ZONING BOARD OF APPEALS APPLICATION

Project Name, If Applicable: COLLINS RESIDENCE

PLAN REVIEW COMMENTS

DESCRIPTION OF WORK : Widen driveway for 2 cars to go to 2 car garage (existing garage).

SITE PLAN

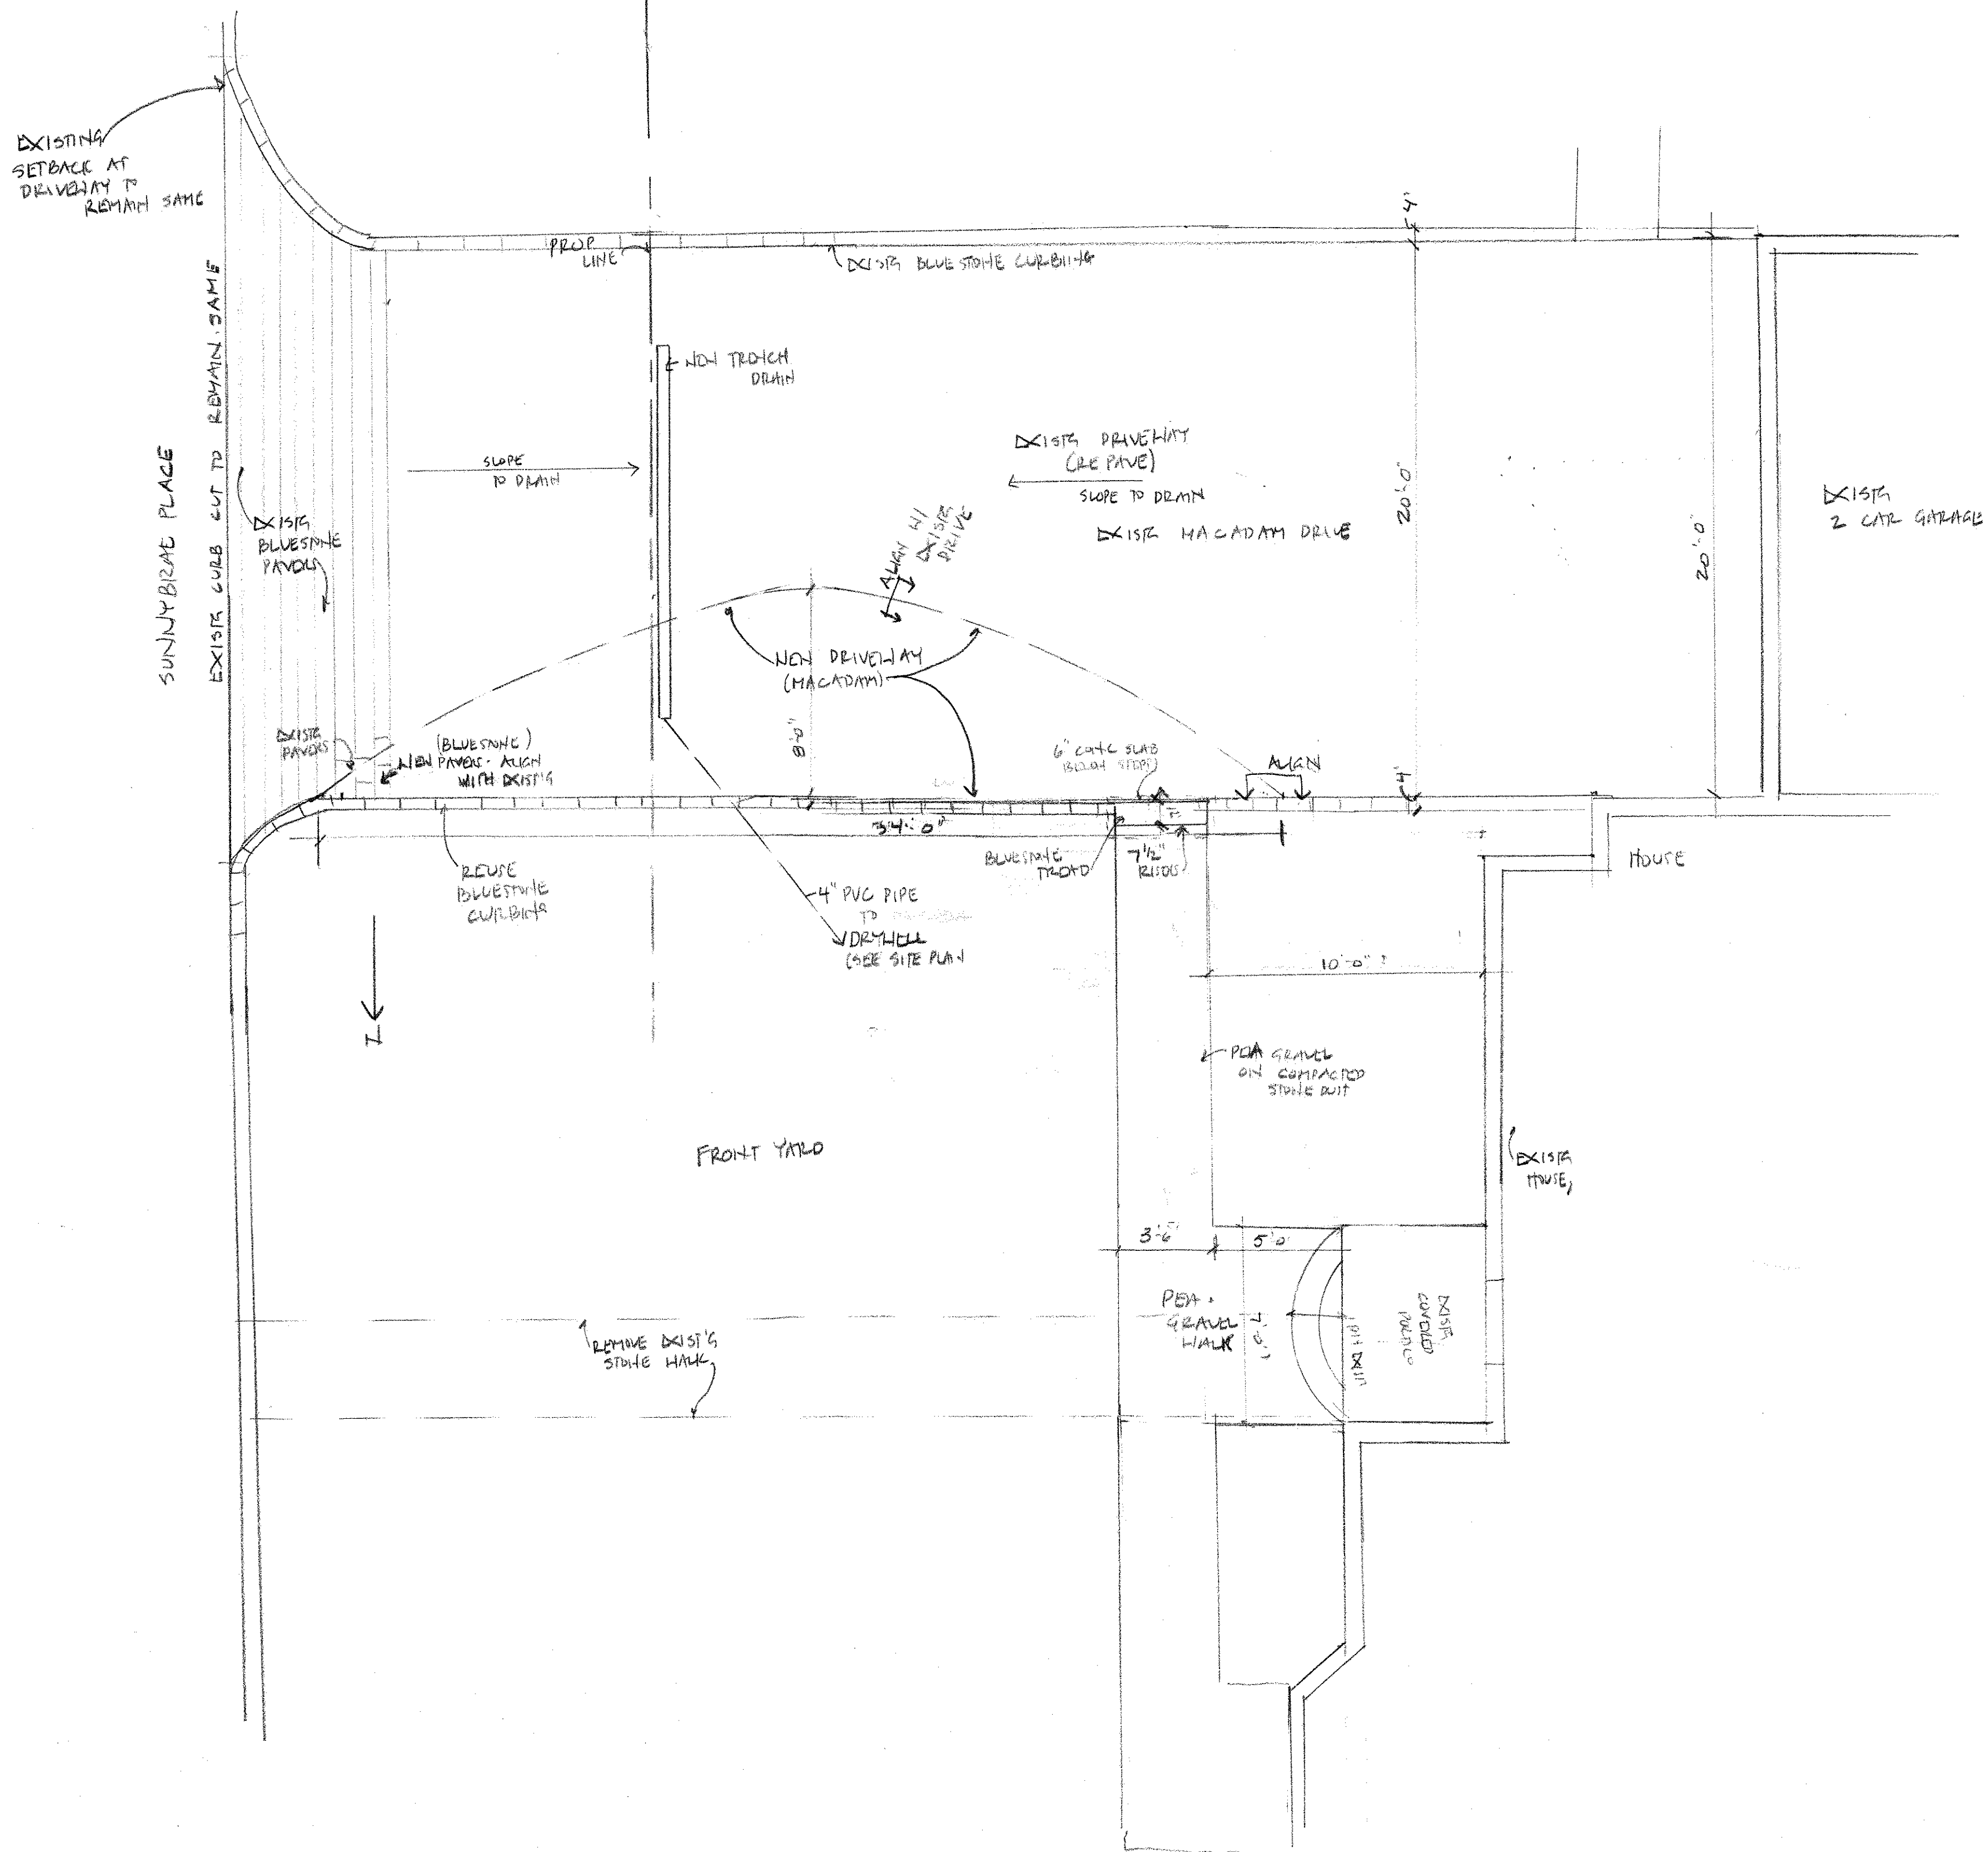
Zoning Review - Plans dated as received 1/20/22

Proposed work is to widen driveway-

1) Proposed work does not appear to comply with 310-22 D

“D. Parking in front yards prohibited in residential districts. Parking spaces or parking areas, with the exception of driveways, shall not be permitted within front yards in any residential district in the Village. For purposes of this section, the portion of any driveway (excluding the 20 feet immediately in front of any garage) that is wider than 12 feet shall be considered to be part of a parking area; except that in the three feet of a driveway closest to the curb, the width of the driveway may gradually fan out to a width of up to 16 feet at the curb. The parking or storage of vehicles upon lawns or other unimproved areas shall not be permitted on any lot improved by a dwelling structure in any residential district in the Village. Circular driveways are deemed front yard parking, except in the One-Family Residence AAA District. In addition, all driveways shall be set back at least three feet from any side yard lot line. Notwithstanding any provision in this Code to the contrary, no existing curb cut may be widened or moved, nor any new curb cut made that is wider than 16 feet at the curb, without both: a variance, and approval, to the extent any driveway is built on Village property, from the Department of Buildings. Where additional parking space is sought in a side yard adjacent to any portion of any permitted driveway space that is located immediately in front of a garage, the width of such additional parking space may not extend more than 8.5 feet towards the adjacent side yard lot line, nor may the length of such additional parking space be more than 20 feet.

Application is referred to the Village of Bronxville ZBA
